VALIDATION OPINION

for Post Registration Changes

**Mokpo Landfill Gas Recovery Project
for Electricity Generation**

UNFCCC Ref. No. 2834

<Figure 1> monitoring diagram in registered monitoring plan

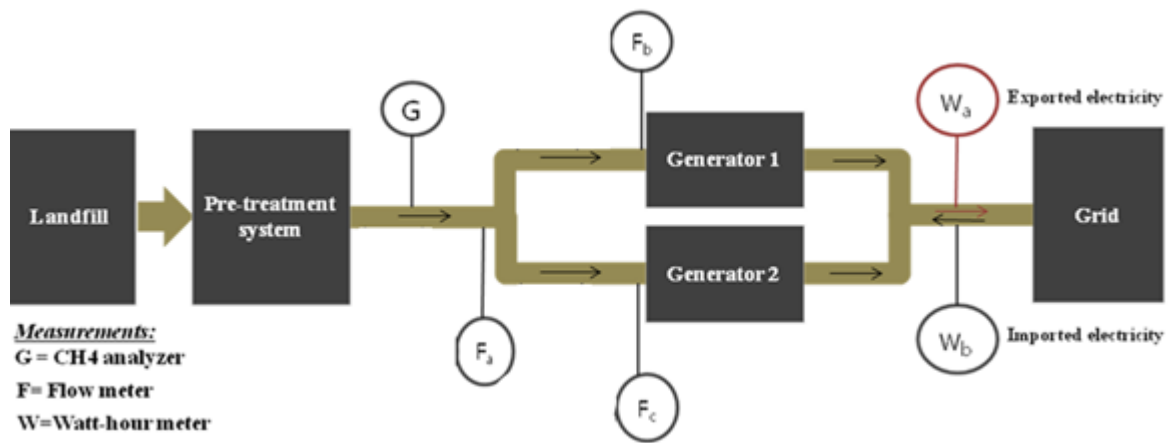
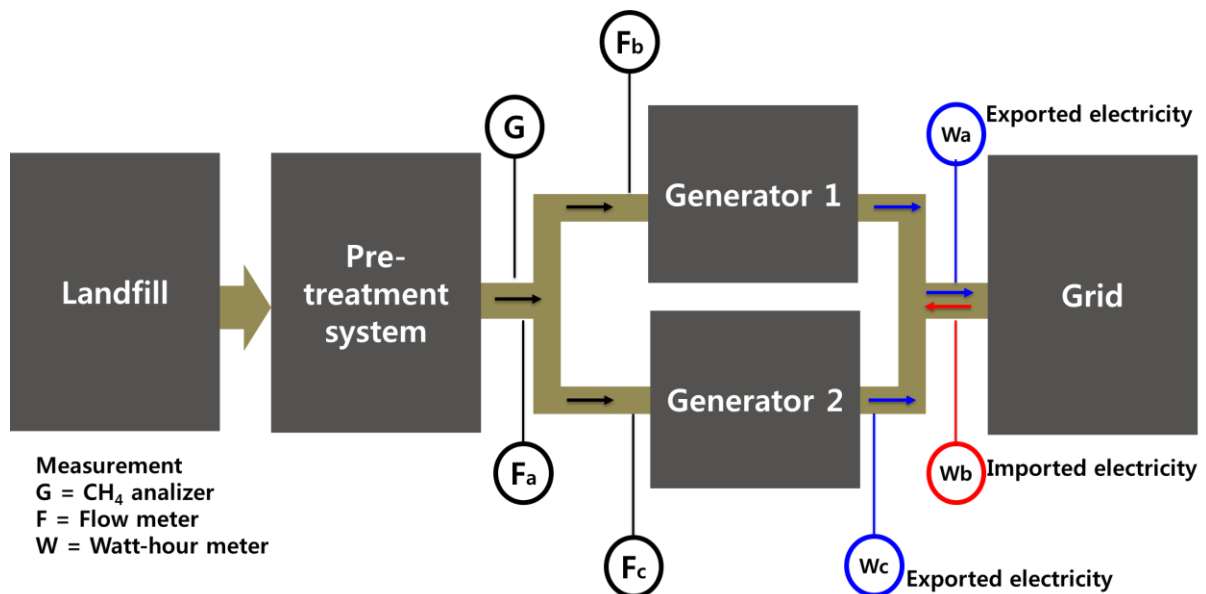
According to the approved revised monitoring plan (approved on 19 January 2011), total amount of electricity exported out of the project ($EL_{EXP,PJT,y}$) is measured by watt-hour meter (Wa) as described in the revised monitoring plan, <Figure 1>.

During the 4th monitoring period, a new watt hour meter (Wc) for measuring exported electricity was installed next to the 2nd generator on 27 January 2013 and has been used since 30 January 2013.

As described in the revised monitoring diagram, <Figure 2>, Wa measures generated electricity from 1st and 2nd generators; Wc measures generated electricity from 2nd generator.

The existing meter (W_a) was measuring exported electricity from both 1st generator and 2nd generator. As per national regulation, “Act on the promotion of the development, use and diffusion of new and renewable energy”, the electricity generation from 1st generator and 2nd generator should be measured separately because the commercial operation starting date is different¹. Accordingly, the PP is requested to measure the electricity generation separately and the PP installed new meter (W_c) to measure electricity from 2nd generator in attendance with KPX, the grid company. The validation team reviewed the national regulation and the official document and confirms that the installation of W_c is not within the control of PP.

When only 1st generator operates or 1st and 2nd generator operate together, the exported electricity is measured by Wa; when 2nd generator operates, the exported electricity is measured by Wc¹. The verification team confirmed through interviewing the PP and relevant personnel in KPX.

The validation team checked the new meter (Wc) during on-site visit and the accuracy is 0.5S, which is in accordance with the national standard, Operational Directive of Korean Electricity Market controlled by KPX requesting the accuracy of 1%. Also, the accuracy of existing meter (Wa) is 0.5S.

Thus, the validation team concluded that the applied accuracy of new meter (Wc) do not reduce the level of accuracy of the monitoring compared with the requirements contained in the registered monitoring plan.

Based on the demonstration above, the validation team can conclude that the proposed revision is appropriate and is in accordance with the applied methodology (AMS I. D version 13 and AMS III. G version 06).
